Access Compliance Report

Public Rights-of-Way

(Curb Ramps)

Intersection ID: N/A	Main Street: S_COLLEGE_ST	Cross Street: E_3RD_ST	Location: E
ADA ID: 850DE7125917	Ramp Type: PerpDiag	Initial Pass/Fail: Fail	Overall Compliance: No
Severity Score: 25			
Codes/Mitigation Info/Possible Solution		Field Measurements/Component Compliance

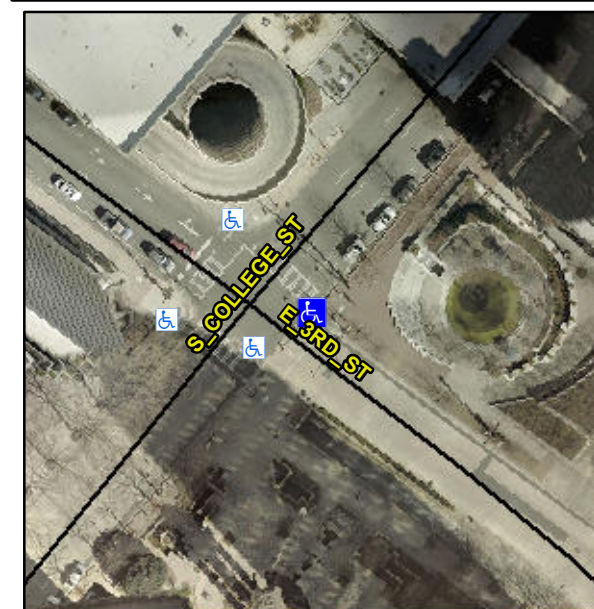
Not Found, R304.5.3

Compliance	Description	Data	Compliance	Description	Data
N/A	Ramp Length (in)	70.0	Yes	Ramp Slope (%)	7.4
Yes	Ramp Width (in)	75.0	No	Ramp XSlope (%)	7.7
N/A	Flare Type LT	N/A	N/A	Flare Type RT	N/A
N/A	Flare Slope LT (%)	N/A	N/A	Flare Slope RT (%)	N/A
N/A	Flare Traversable LT?	N/A	N/A	Flare Traversable RT?	N/A
N/A	Landing Length (in)	N/A	N/A	DWS Provided?	N/A
N/A	Landing Width (in)	N/A	N/A	DWS Contrast?	N/A
N/A	Landing Slope (%)	N/A	N/A	DWS Length (in)	N/A
N/A	Landing X Slope (%)	N/A	N/A	DWS Full Width?	N/A
N/A	Landing Curb? (Y/N)	N/A	N/A	DWS Offset (in)	N/A
N/A	Shared Landing?	N/A			
N/A	Gutter Ponding?	N/A	N/A	Gutter Slope (%)	N/A
N/A	Gutter Lip Ht (in)	N/A	N/A	Gutter X Slope (%)	N/A
N/A	Painted X Walk1?	Yes	N/A	Painted X Walk2?	Yes
	X Walk 1 Direction	To NW		X Walk 2 Direction	To SW
N/A	X Walk 1 Width (in)	109.0	N/A	X Walk 2 Width (in)	114.0
	X Walk 1 Slope (%)	5.3		X Walk 2 Slope (%)	1.3
	X Walk 1 X Slope (%)	0.2		X Walk 2 X Slope (%)	5.6

N/A	Ramp inside XWalk1?	Yes	N/A	Ramp inside XWalk2?	Yes
	Road Slope (%)	6.4	N/A	Clear Space?	N/A
	Road X Slope (%)	8.4	N/A	Clear Space to XWalk (in)	N/A
N/A	Any Obstructions?	N/A	N/A	Storm Grate/Utility Hazard?	N/A
	Obstruction Type			Storm Grate/Utility Type	
		N/A			N/A
		Yes		Surface Condition? (G/P)	Good

Remove & Replace Curb Ramp With Two New Directional Ramps or Equivalent.
